The M.G. Car Company, Ltd.

The M.G. Midget (Series J1 and J2)

### SERVICE INFORMATION No. 2 J

#### MUD PROTECTION ON THE J2 TWO-SEATER

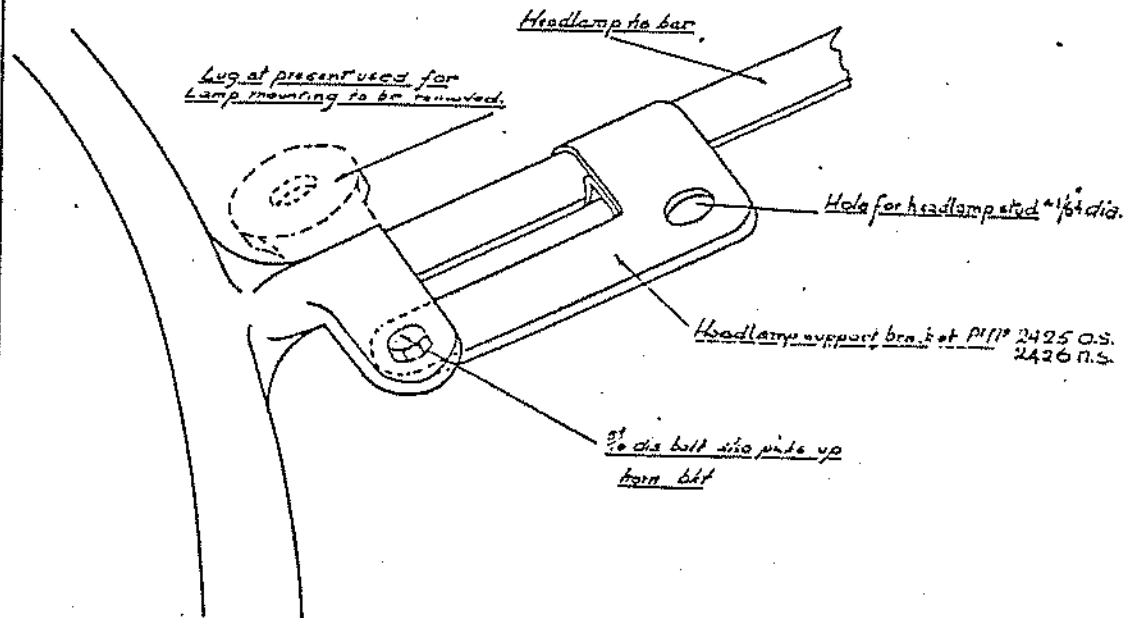
A number of complaints have been received to the effect that in wet weather the J2 model throws so much mud on to the windscreen in line with the driver's eyes that it makes the car unpleasant to drive.

As a first test the headlamps were removed and it was promptly found that the trouble had disappeared, the lamps were re-fitted and the trouble returned as before.

The problem was therefore primarily a question of how to mount the headlamps in a position which cures the trouble without spoiling the appearance of the car.

The drawing shows how this is done. The existing headlamp support lugs are cut off and filed up, the bare patch so caused being touched in with cellulose.

Headlamp support brackets Part Nos. 2425 offside and 2426 nearside are then fitted in position utilizing the existing front lugs. The headlamps can then be mounted in a new position further forward and closer together which is the best position so far found.
